INDIANA DEPARTMENT OF TRANSPORTATION

APPROVED MINUTES

April 15, 2010 Standards Committee Meeting

RE: Minutes for the April 15, 2010 Standards Committee Meeting

PROPOSED REVISION TO STANDARD DRAWING E 610-PRAP-0201 PUBLIC ROAD APPROACH TYPE A

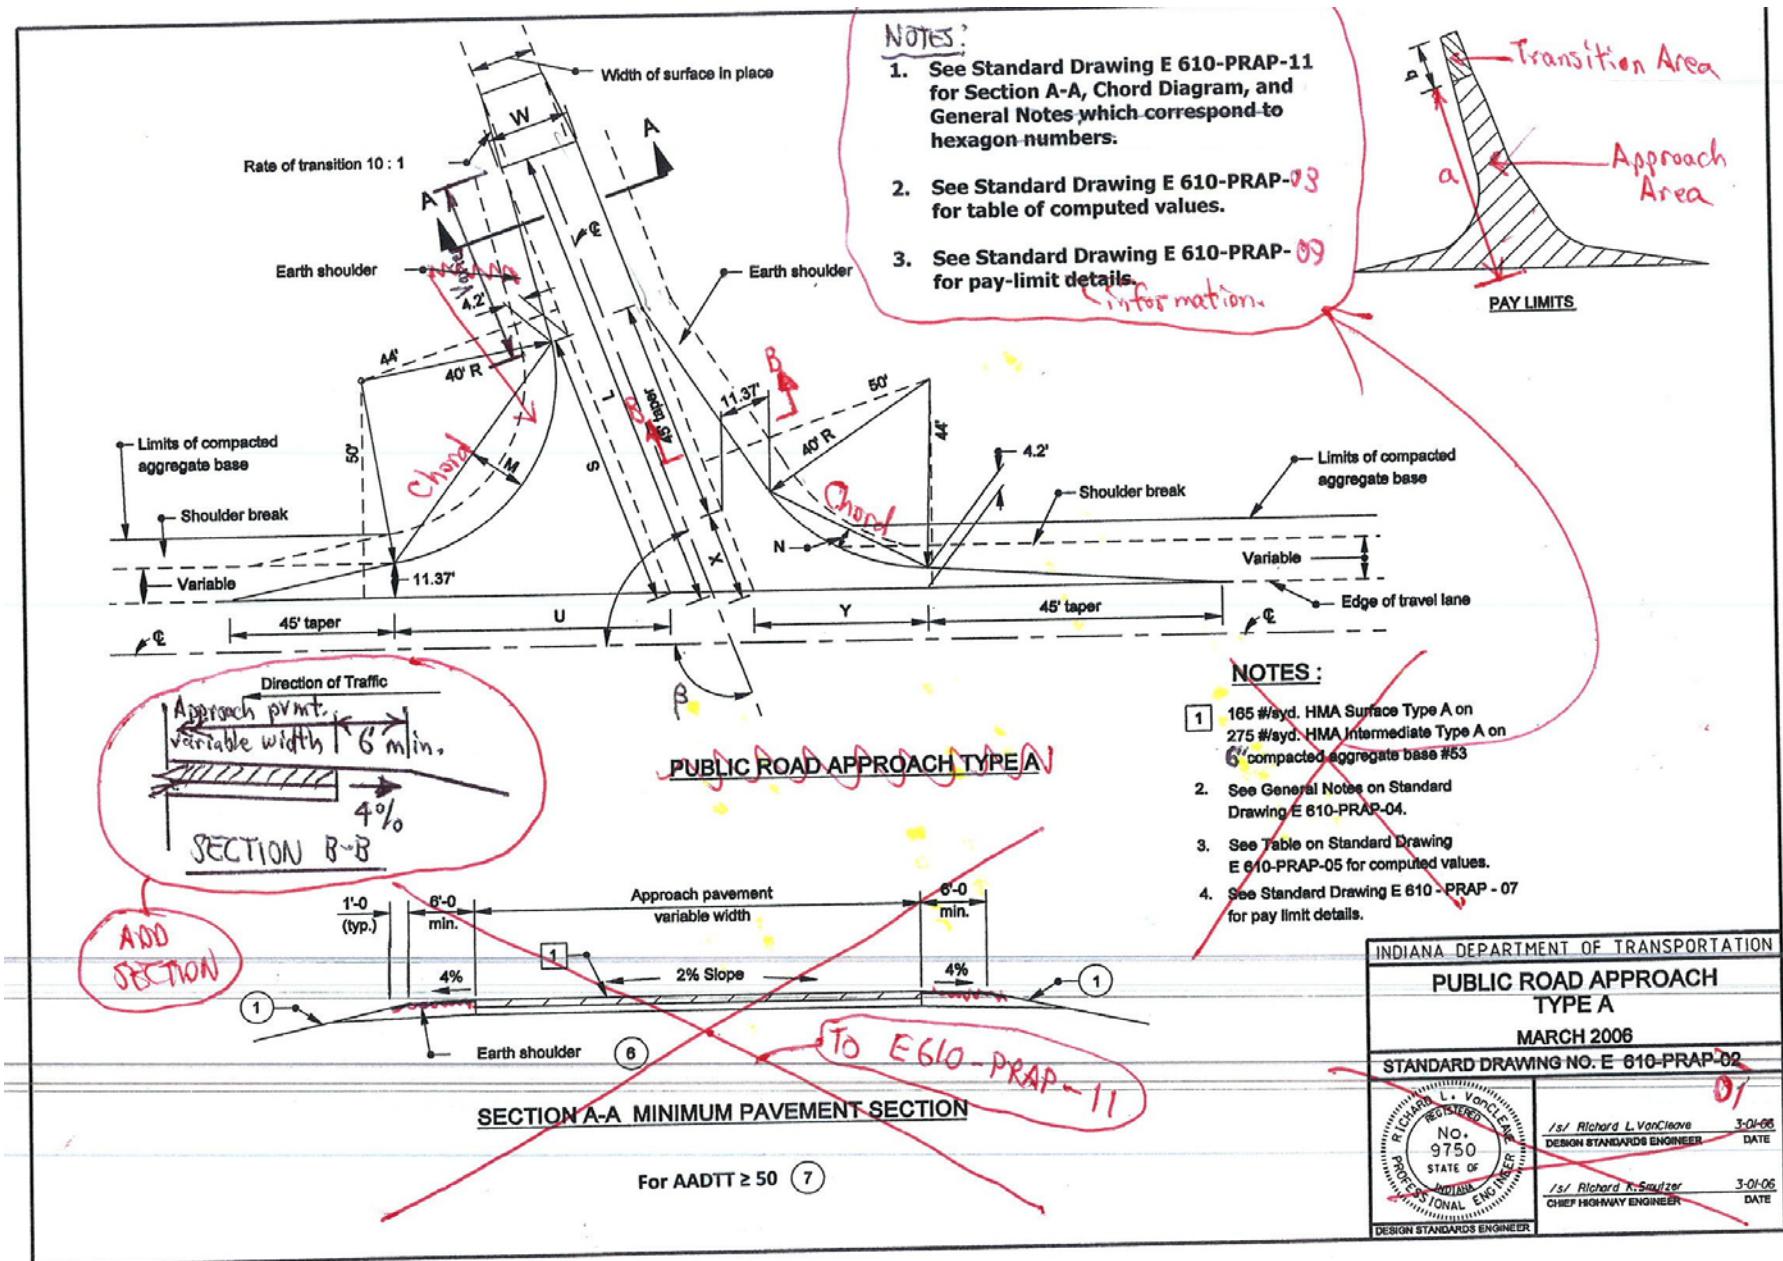
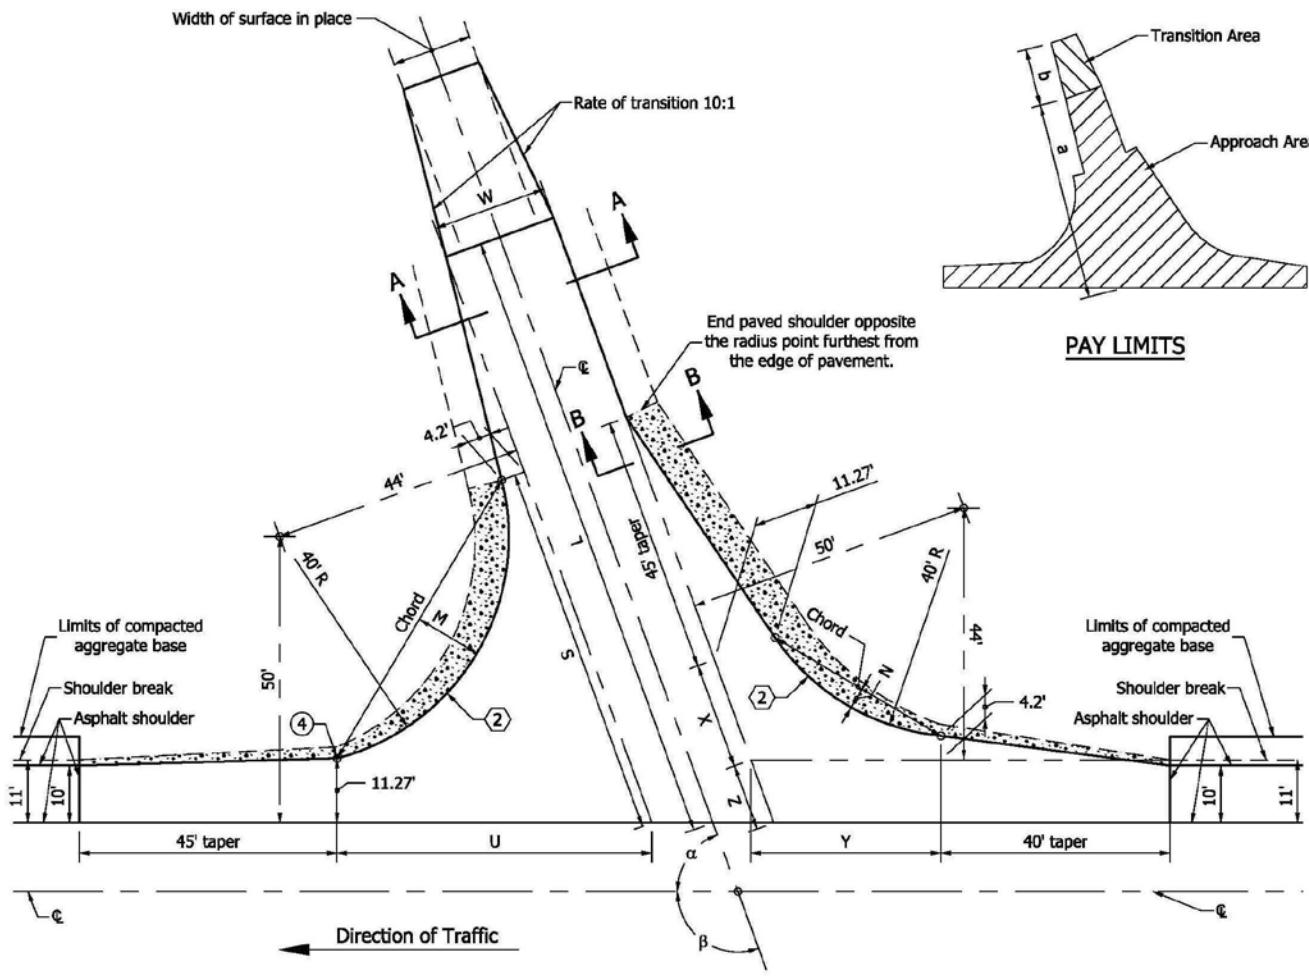
PROBLEM(S) ENCOUNTERED: OLD BUSINESS - Item No. 04 on the 01/21/10 agenda (submitted by Dave Andrewski) was passed as Revised. Standard drawings 610-PRAP-02 thru 12 plus sheet 713-TCTR-04 were made up for revisions for decreased pavement thicknesses due to the MEPDG. Those revisions and general cleanup of notes and figures were done as shown.

MARKED UP REVISION TO CURRENT STANDARD DRAWING E 610-PRAP-02 PUBLIC ROAD APPROACH TYPE A

PROPOSED REVISION TO STANDARD DRAWING E 610-PRAP-0709 PUBLIC ROAD APPROACH PAY LIMITS

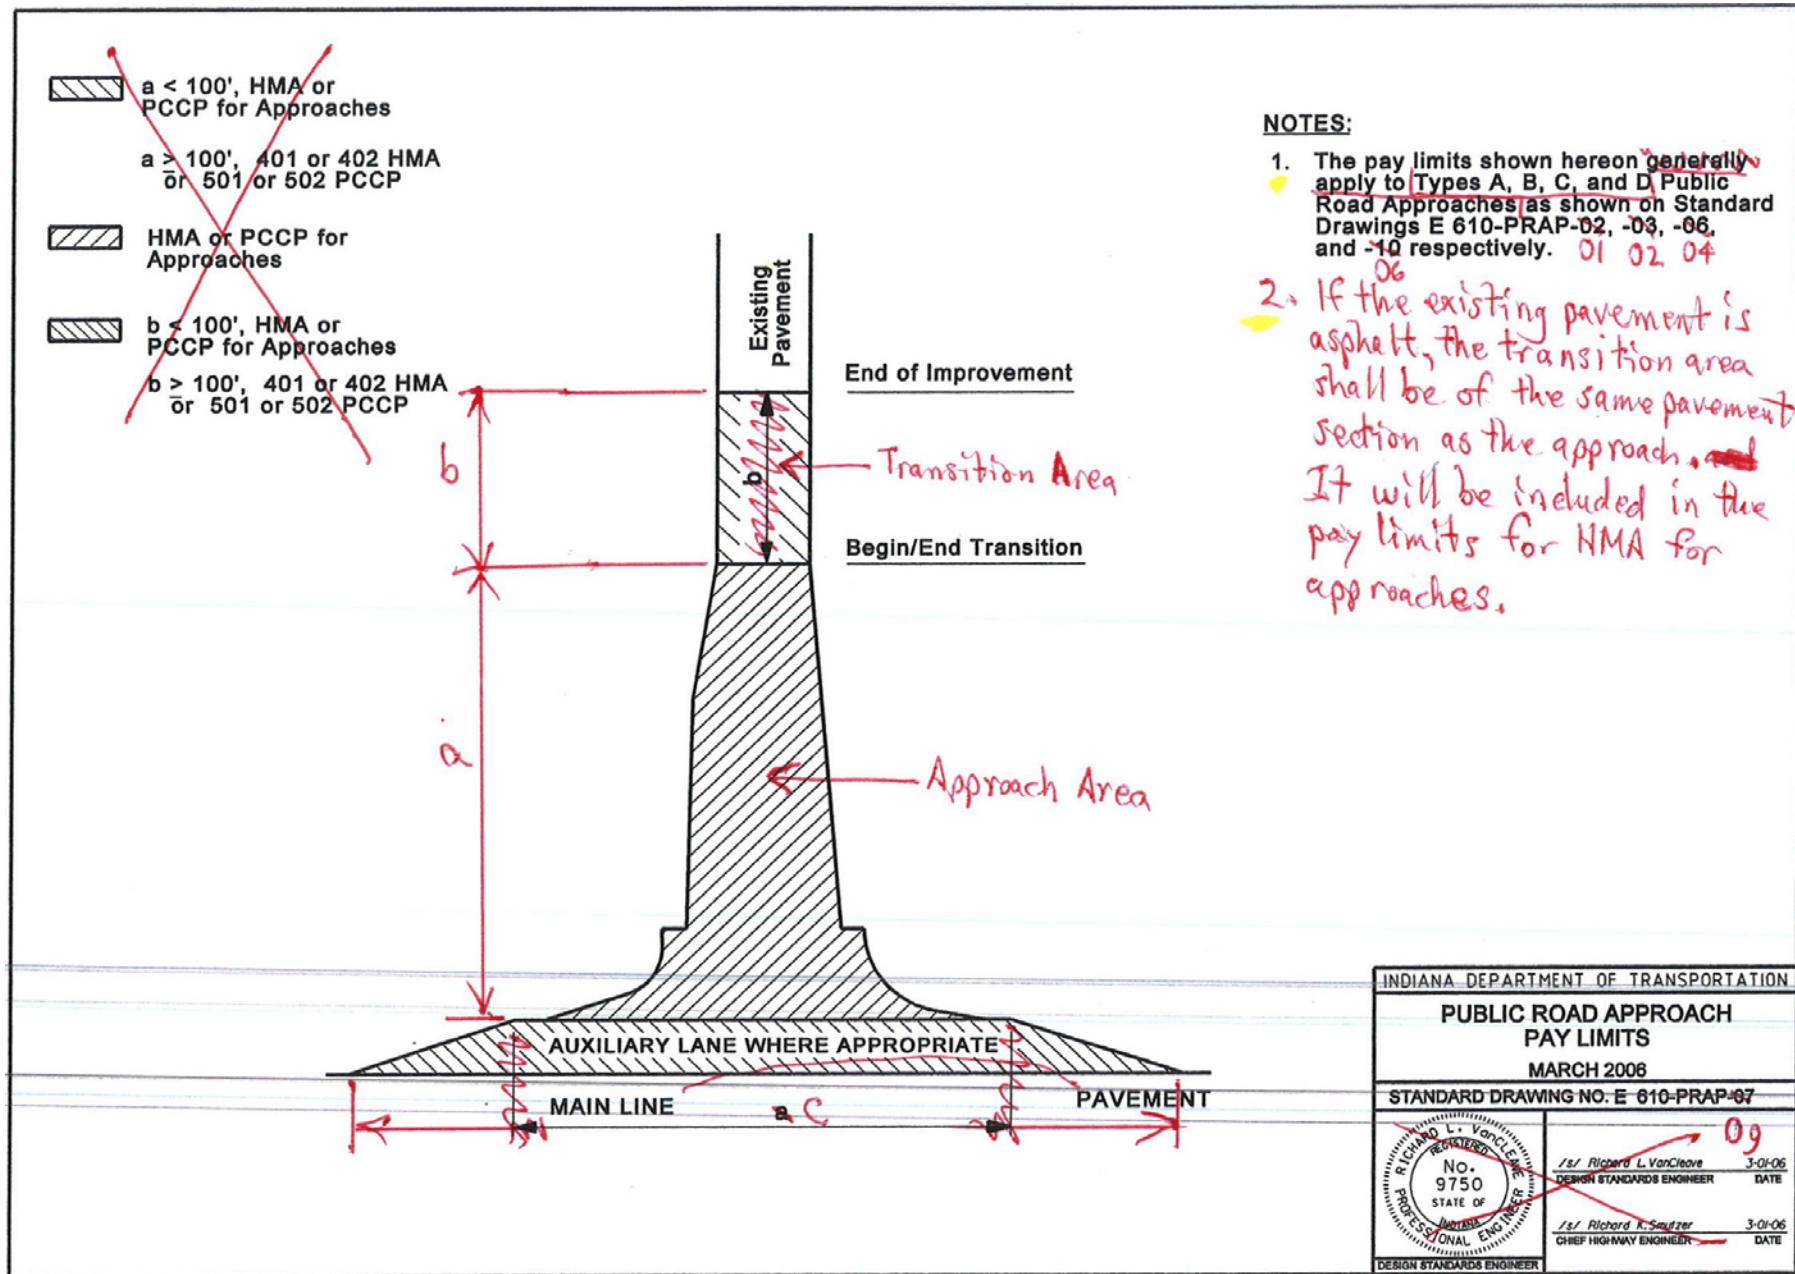
MARKED UP REVISION TO CURRENT STANDARD DRAWING E 610-PRAP-07 PUBLIC ROAD APPROACH PAY LIMITS

DISCONTINUED STANDARD DRAWING E 610-PRAP-11 PUBLIC ROAD APPROACH TYPE D GENERAL NOTES AND TABLE A

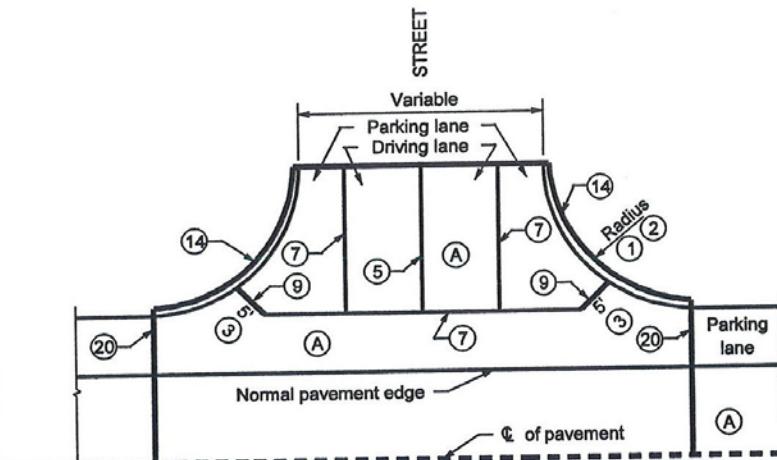
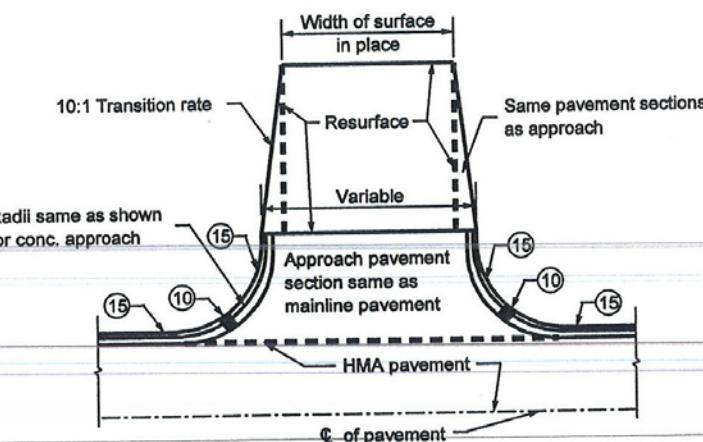
ELIMINATE THIS DRAWING. IT DUPLICATES AND CONFLICTS AND INFO NOW ON 610-PRAP-13.

REVISED PROPOSED DRAWING E 616-SWCO-07 SLOPEWALL AND DRAINAGE DETAILS

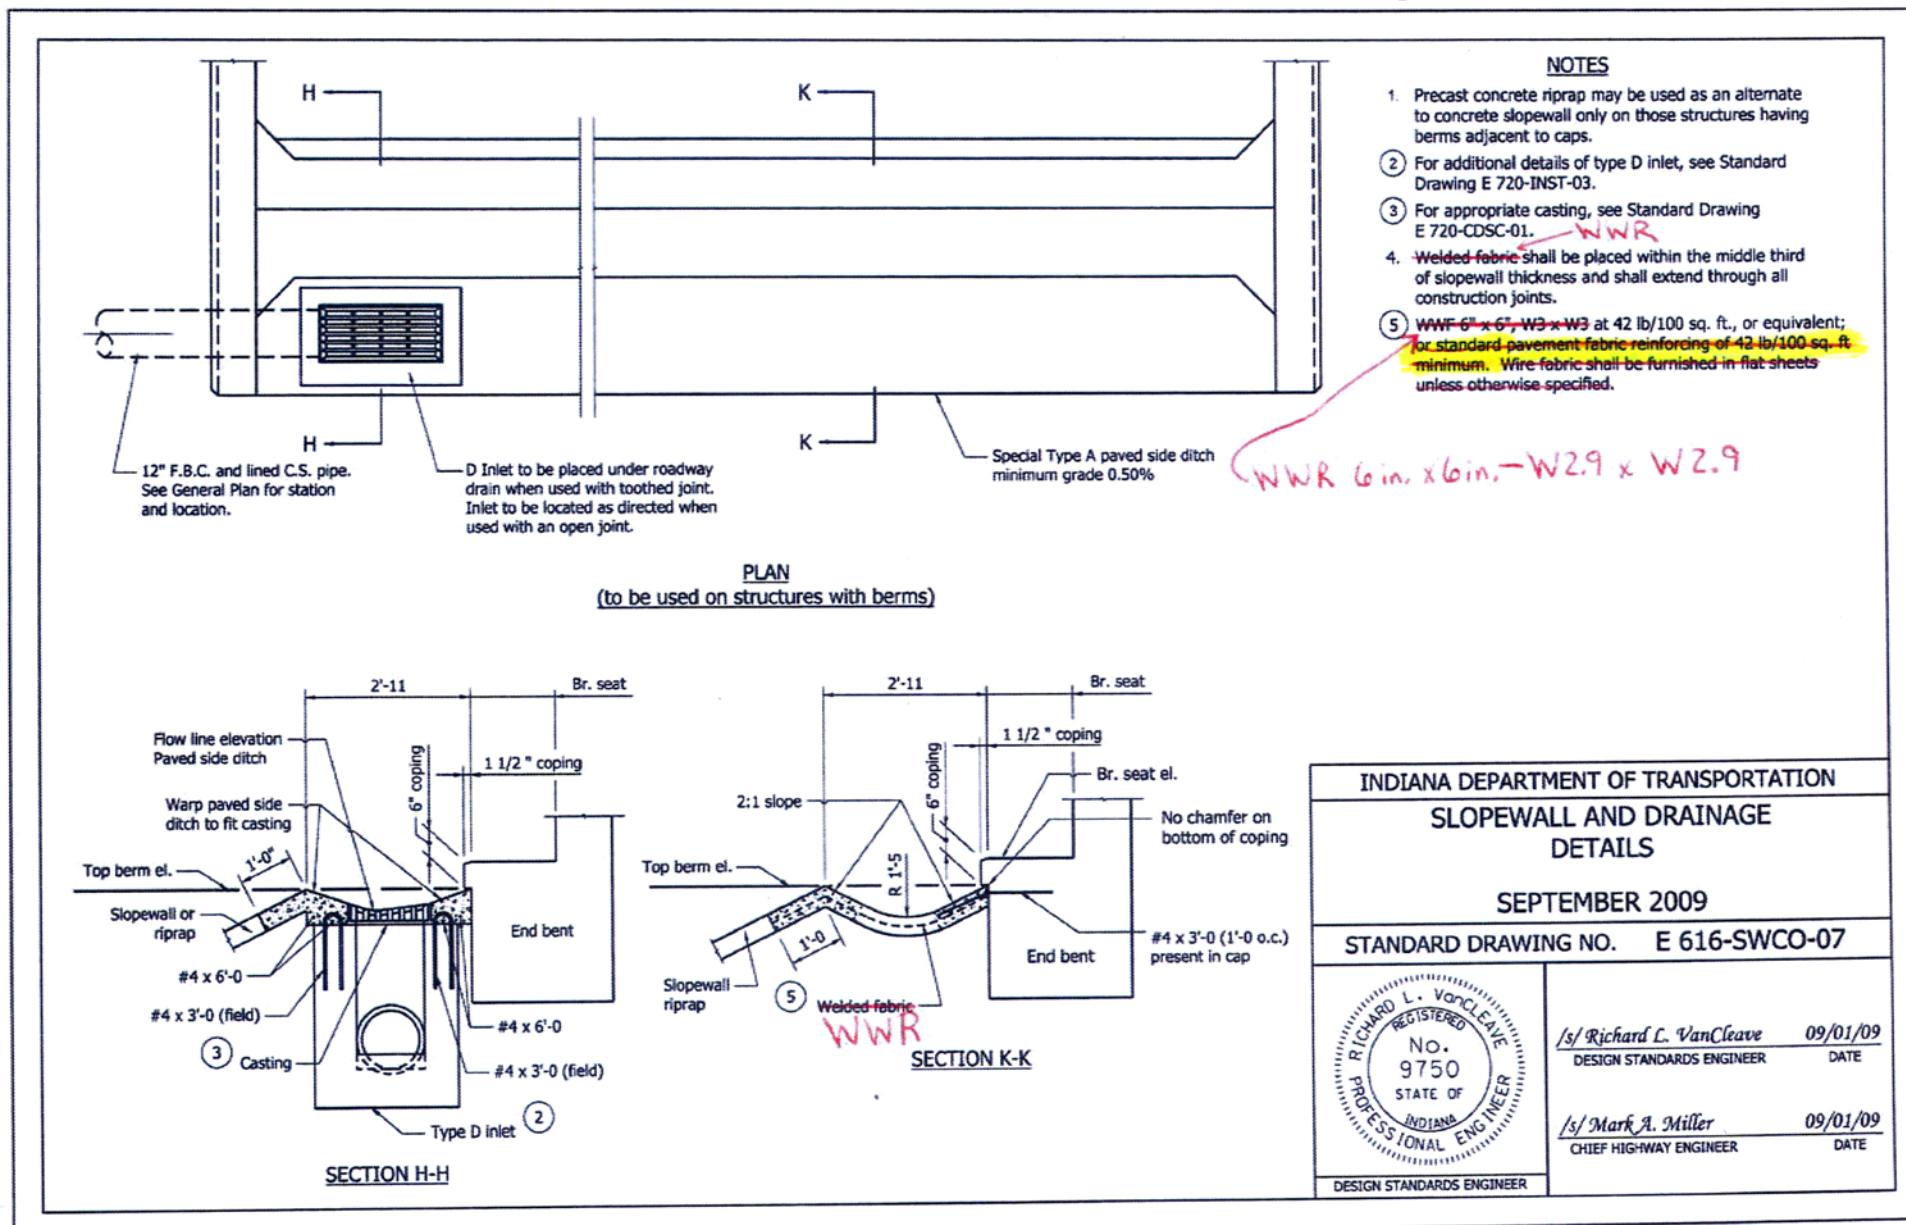
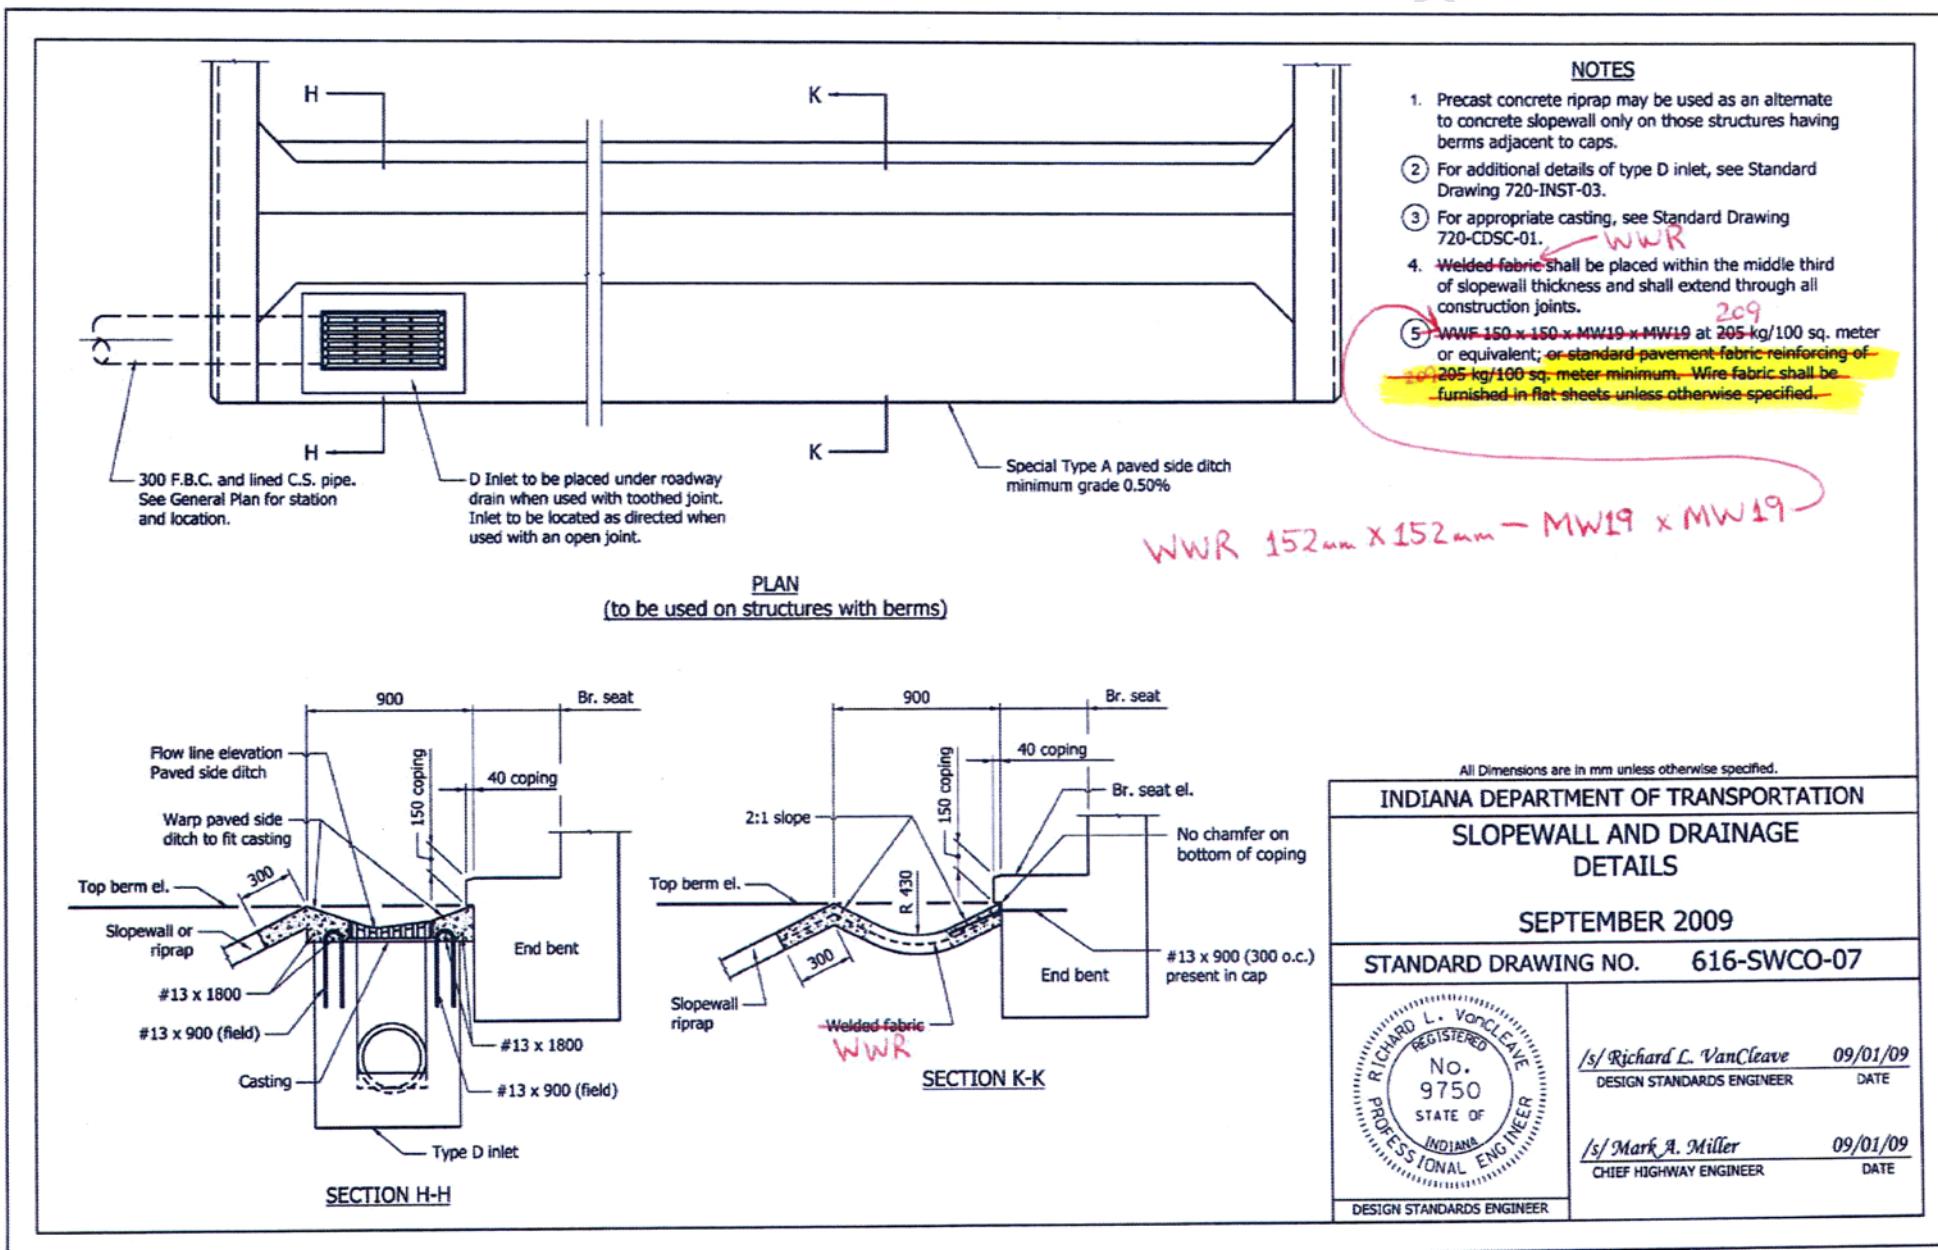
PROPOSED SOLUTION: Delete the WWR style designation from 616 as it is duplicated on the standard drawing 616-SWCO-07. Correct the style designation on this standard drawing.

~~Welded wire reinforcement shall be 6 in. by 6 in. (150 mm by 150 mm) mesh, W-3 x W-3 wires, with a weight (mass) per square area of 42 lb/100 ft² (205 kg/100 m²).~~

Correct the naming convention on the following standard drawings: 616-SWCO-03, 616-SWCO-04, 616-SWCO-06, 616-SWCO-07, 616-SWRR-01, 616-SWRR-02 to the WWR convention. Since the changes to the naming convention on these drawings is editorial in nature, they have not been included in this submittal.
